## AMENDMENT 2

- 2 BUNGALOW HOMES ADDED
- N. QUEMOY CT. EXTENDED NORTH
- BUFFER LANDSCAPE ALONG PICADILLY PHASED

GREEN VALLEY RANCH EAST  
PRELIMINARY SITE PLAN #5  
TITLE: KEYMAP  
DATE: March 8, 2023

**N3** TWO-FAMILY HOME (MID-BLOCK) 85'-100' X 95'  
NTS

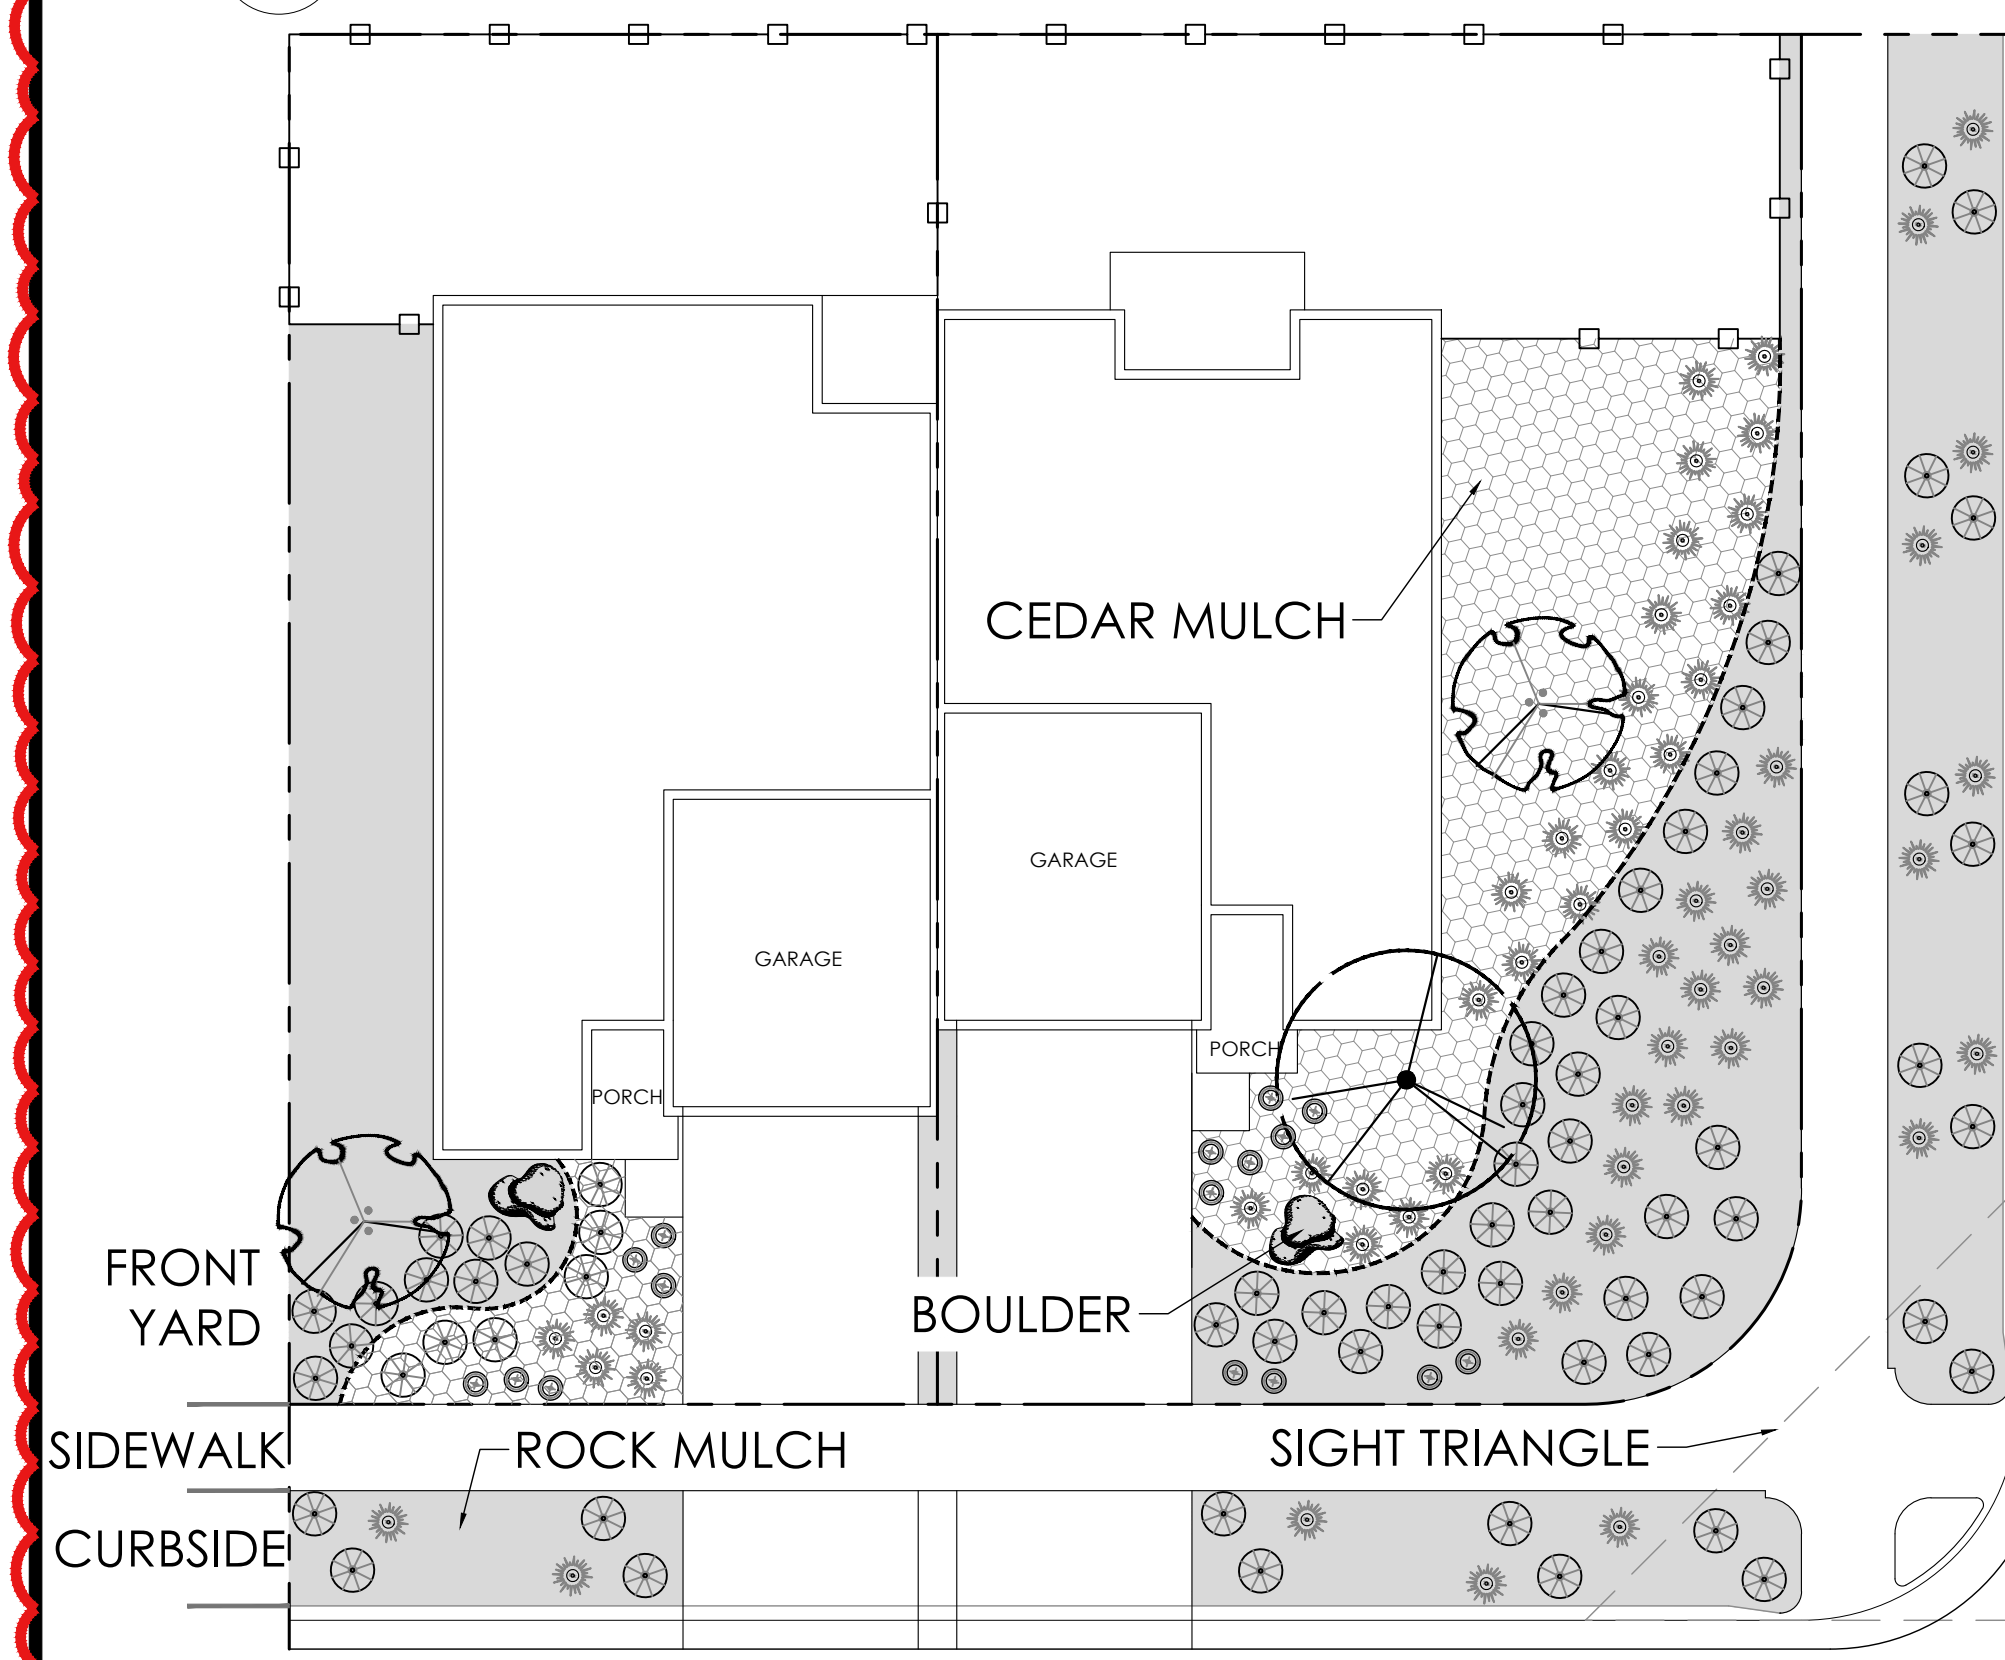
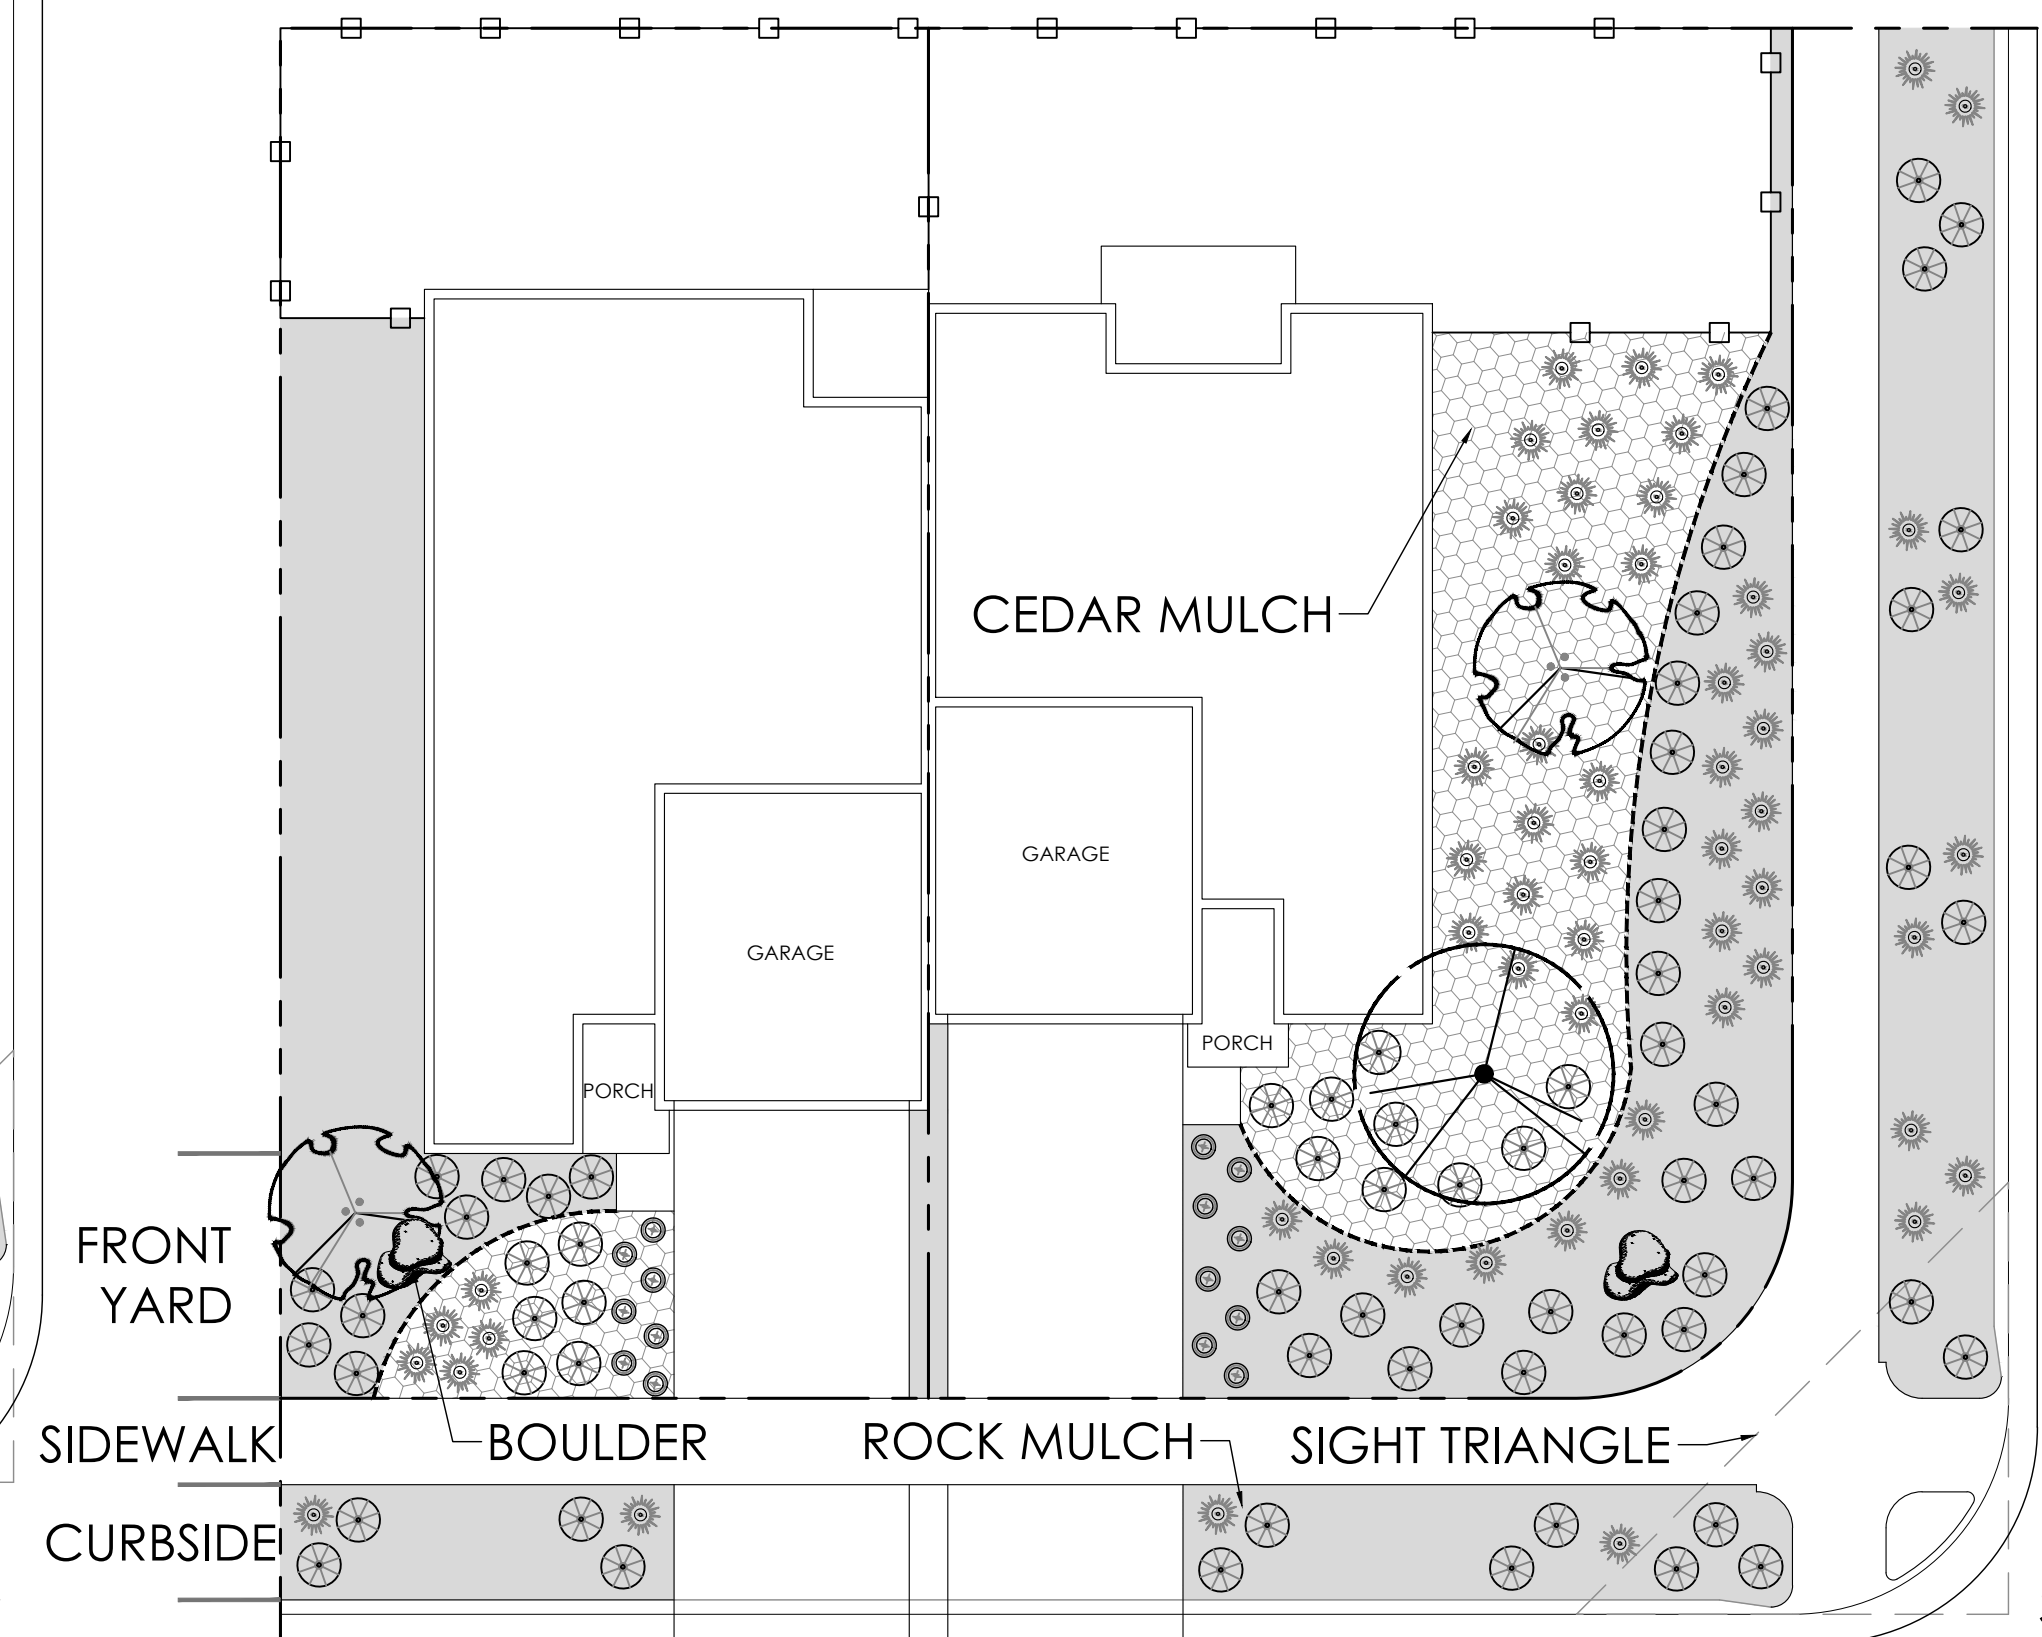
**AMENDMENT 3**  
22 LOTS CHANGED FROM SINGLE FAMILY DETACHED HOMES TO TWO-FAMILY ATTACHED HOMES (DUPLEX). NO CHANGE IN UNIT QUANTITY
